RADIO RECEIVERS R-274/FRR, R-274A/FRR, R-274C/FRR, AND R-274D/FRR

CHANGES No. 2

HEADQUARTERS,
DEPARTMENT OF THE ARMY
WASHINGTON 25, D.C., 8 March 1962

CHANGES }
No. 1 }DEPARTMENT OF THE ARMY
WASHINGTON 25, D. C., 12 May 1954

Figure 49.1. (Added) Radio receiver R-274D/FRR, schematic diagram.

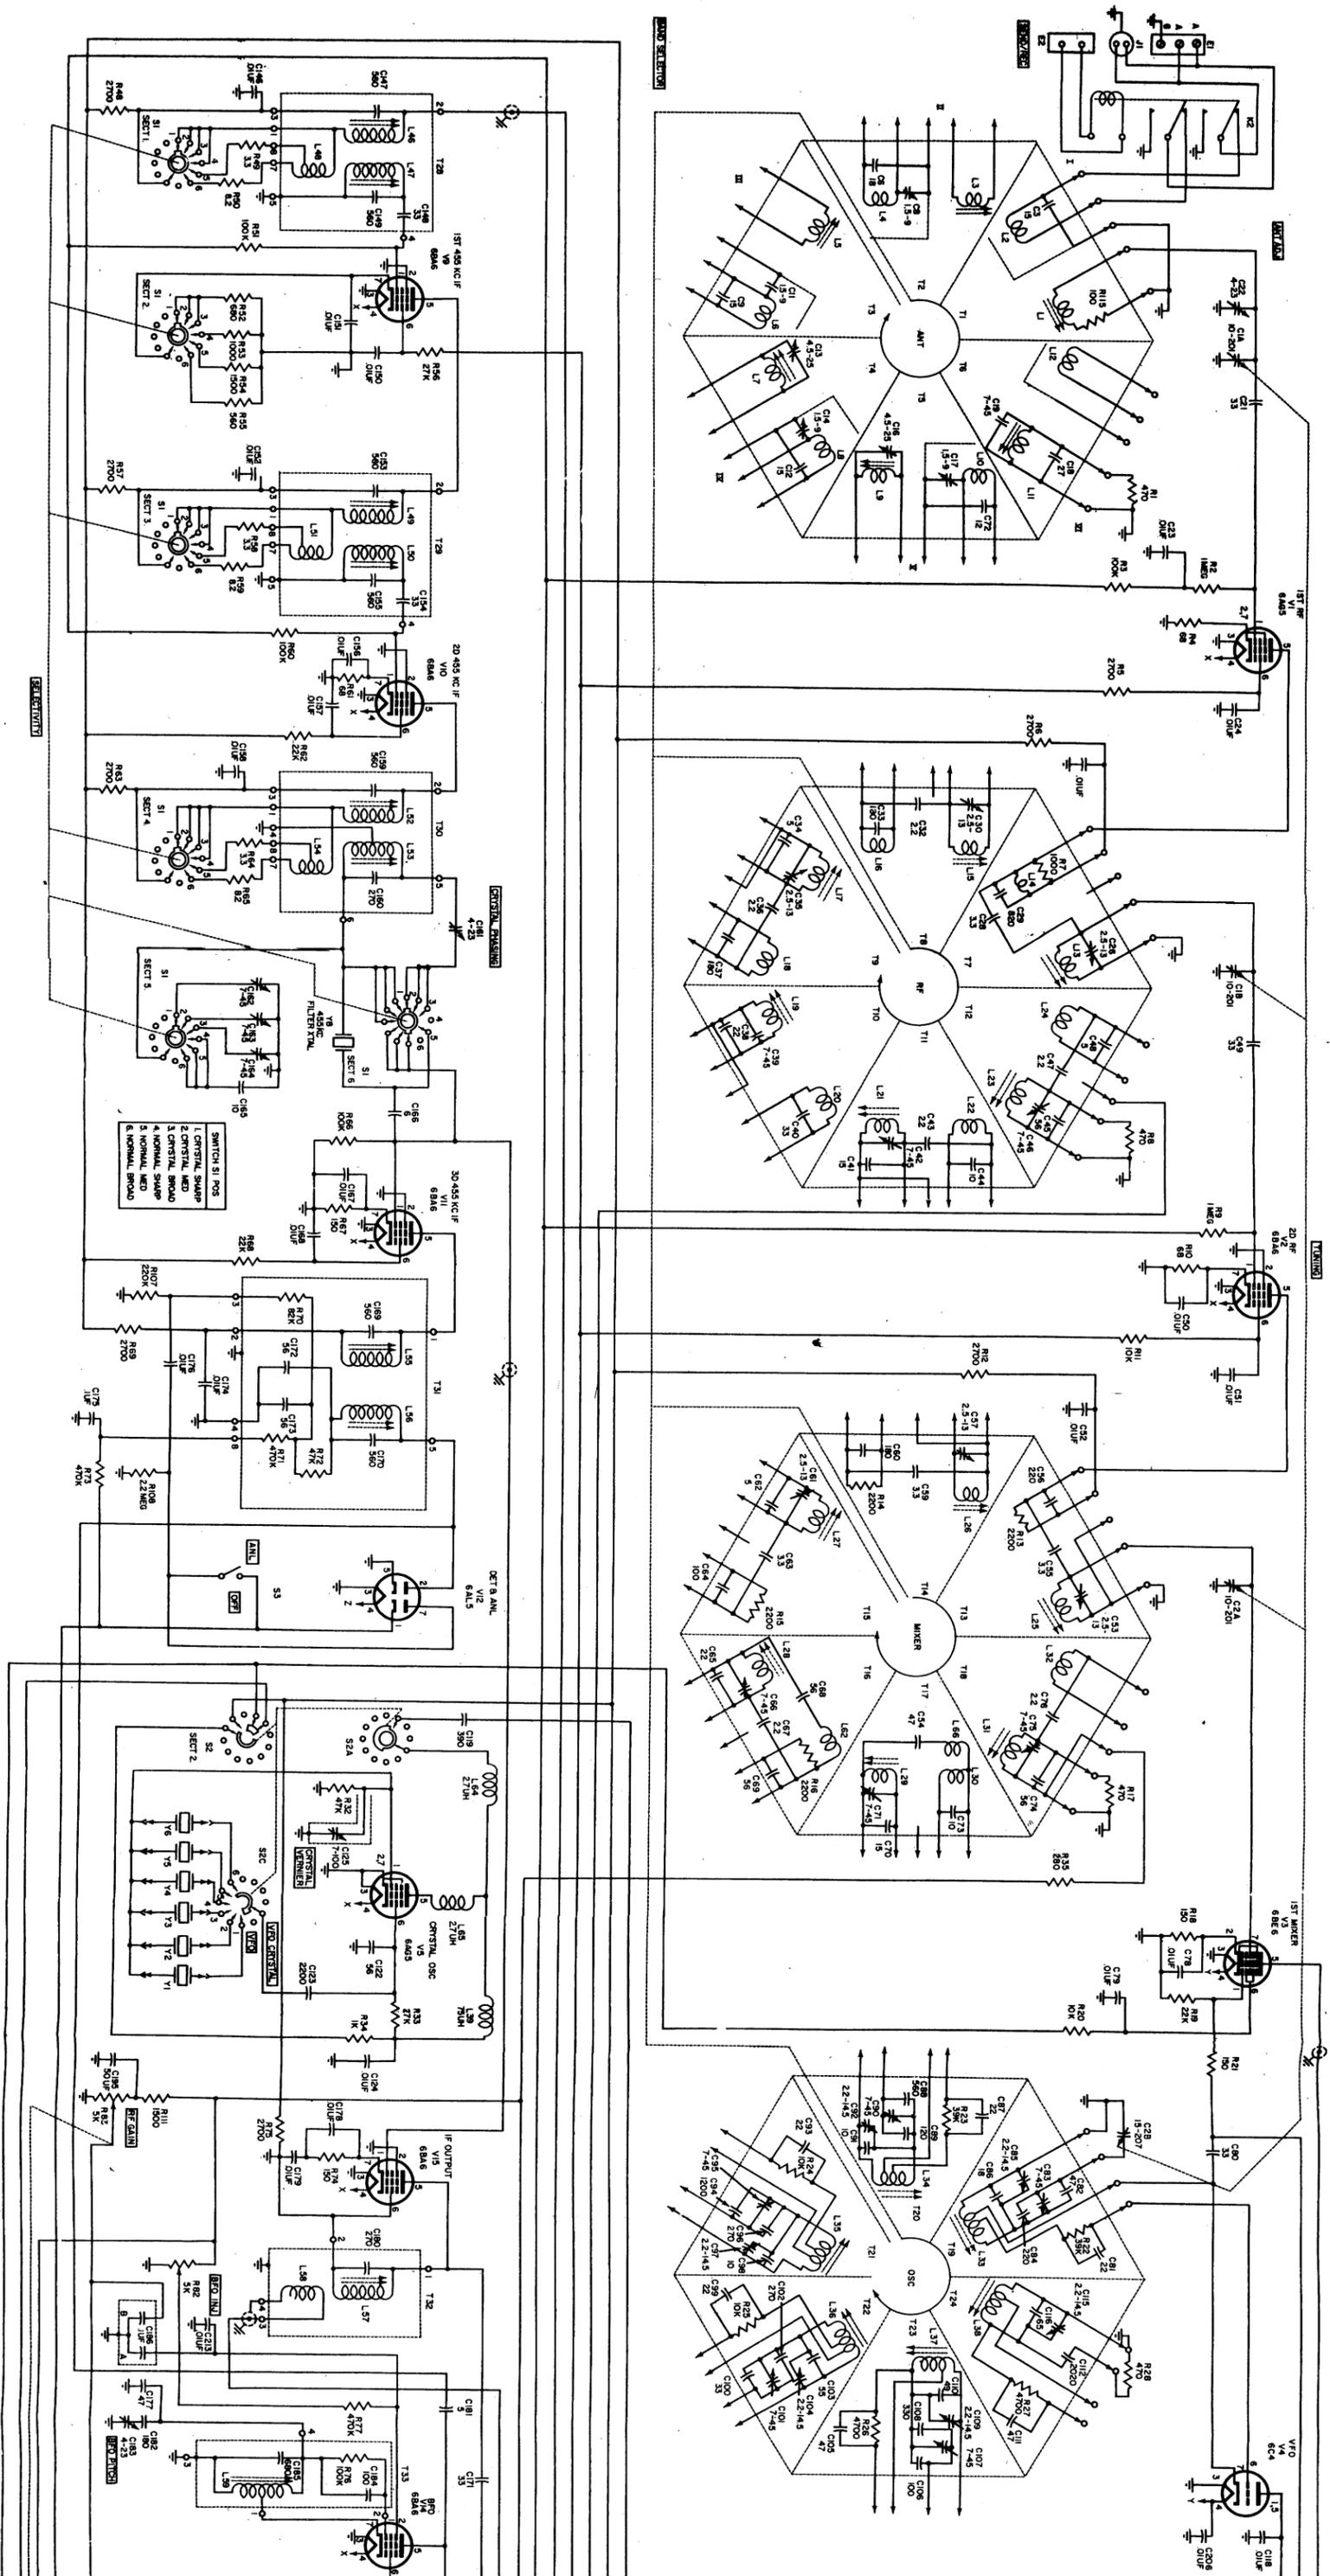
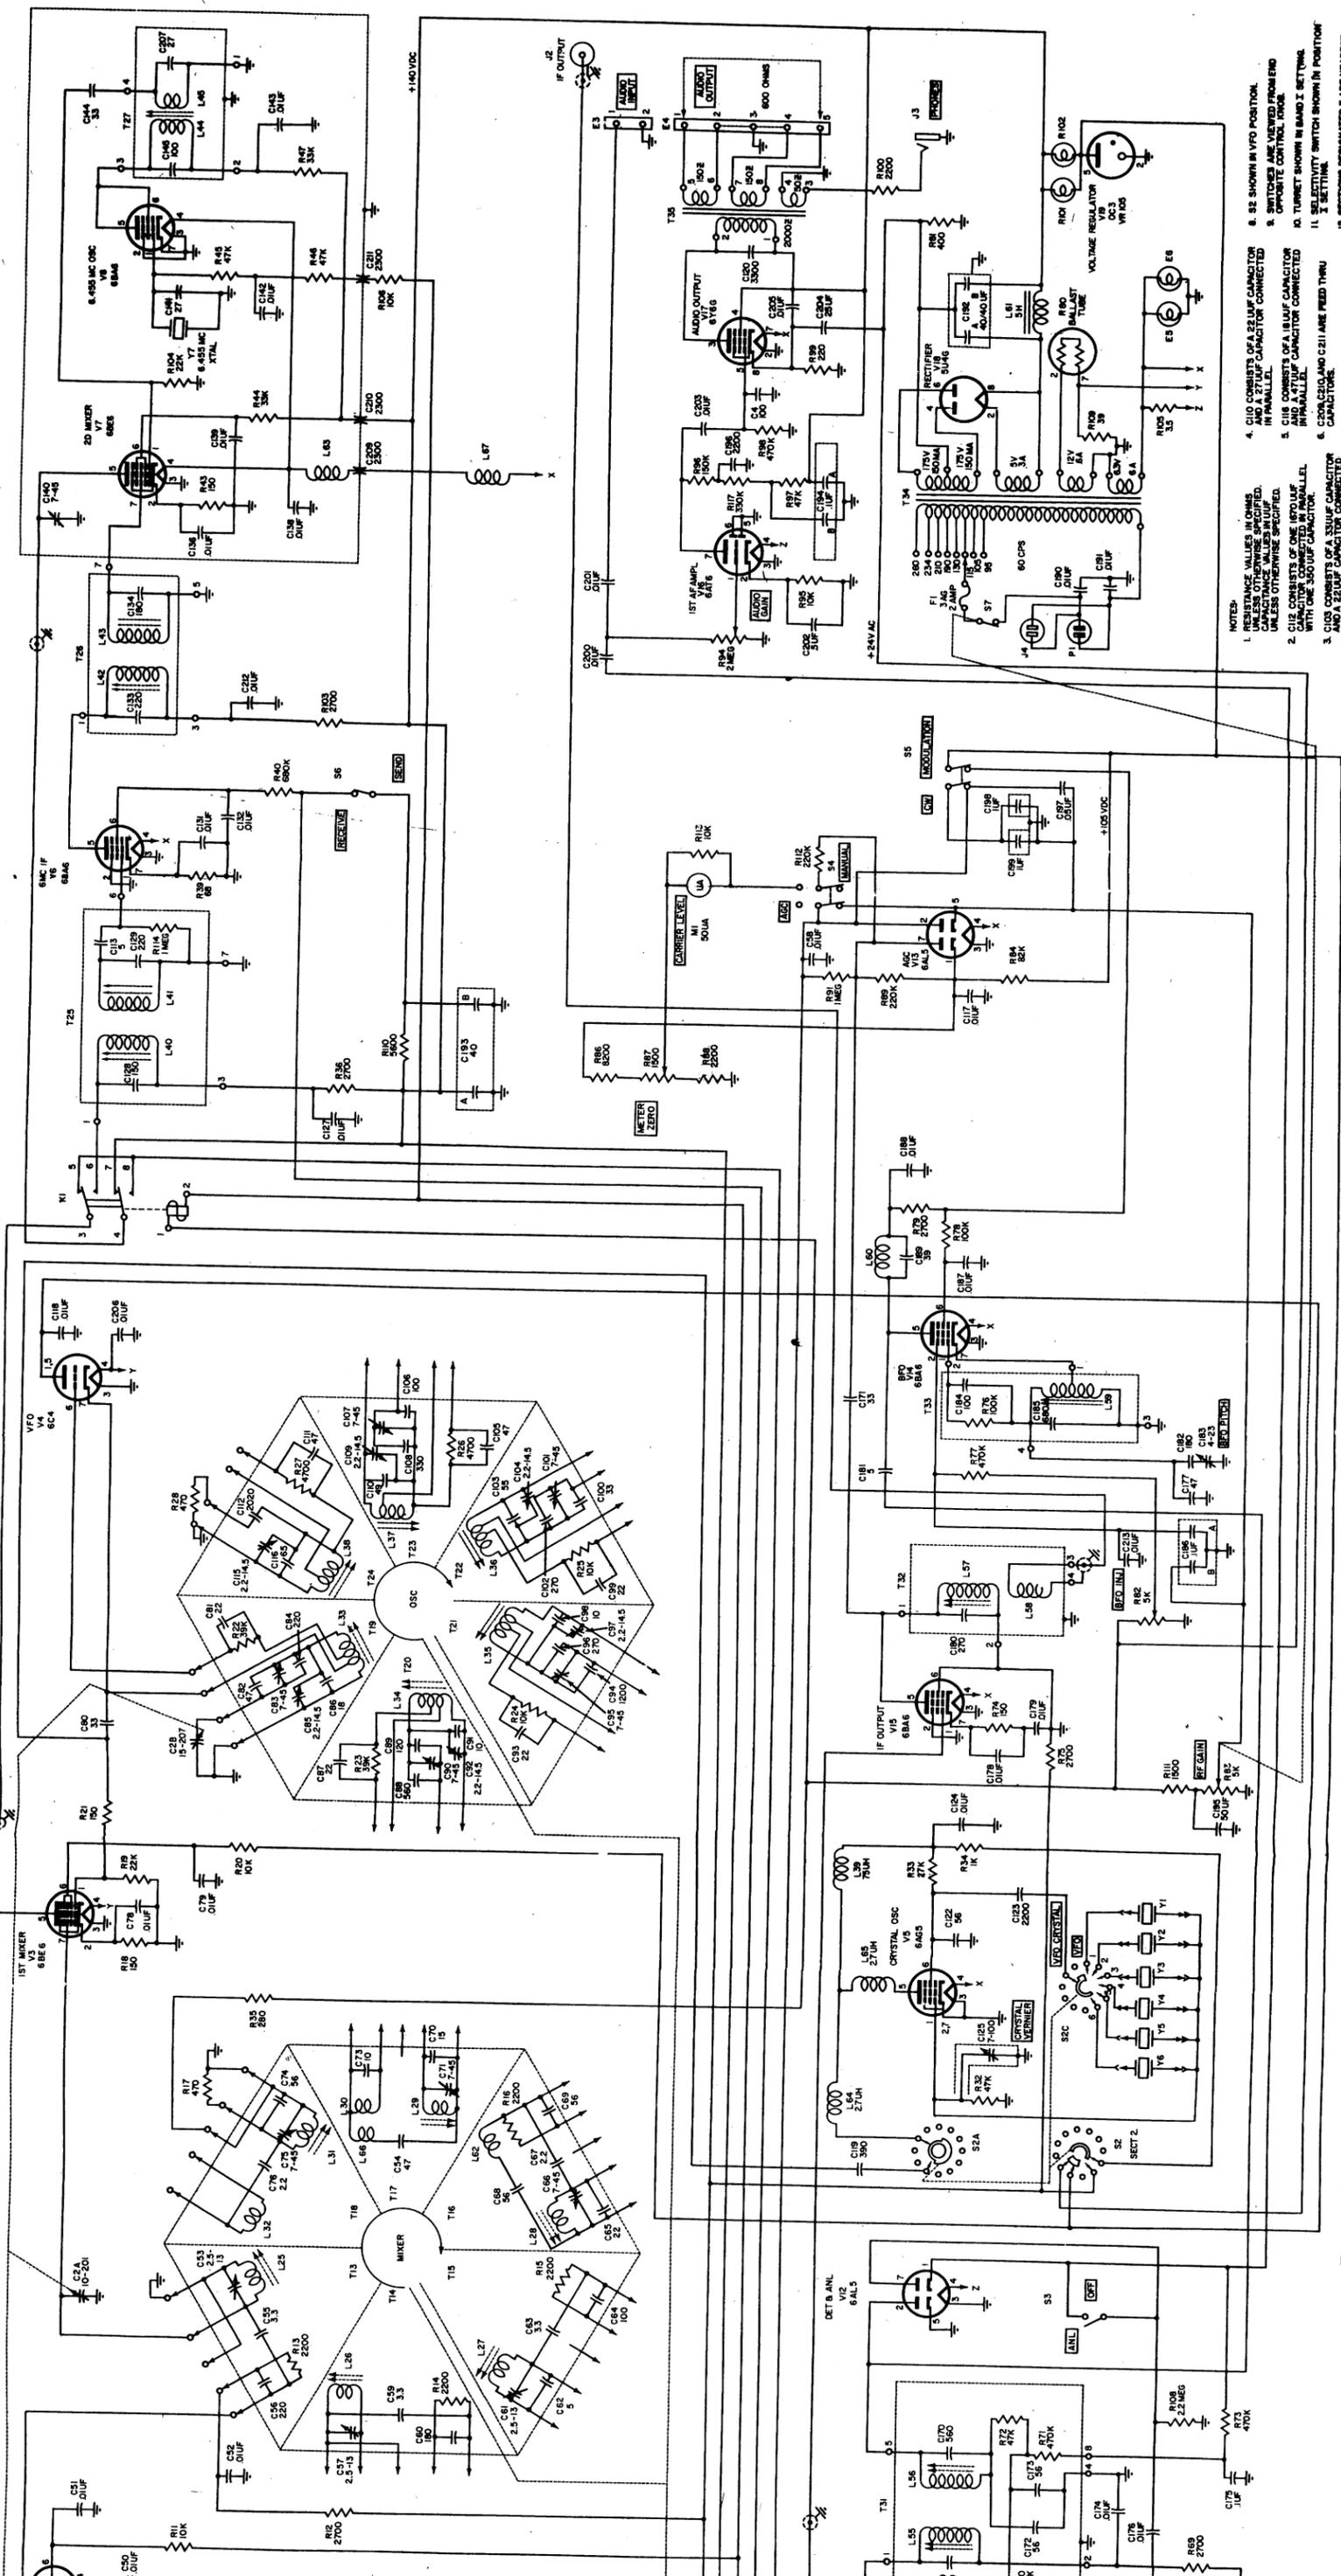
Figure 43.1. The following note is added:

14. IN RADIO RECEIVER R-274D/FRR, SERIAL NUMBERS 674 THROUGH 1266 ON ORDER NO. 3464-PHILA-52, A NEON LAMP E53 IS CONNECTED ACROSS THE ANTENNA DISABLING RELAY CONTACTS.
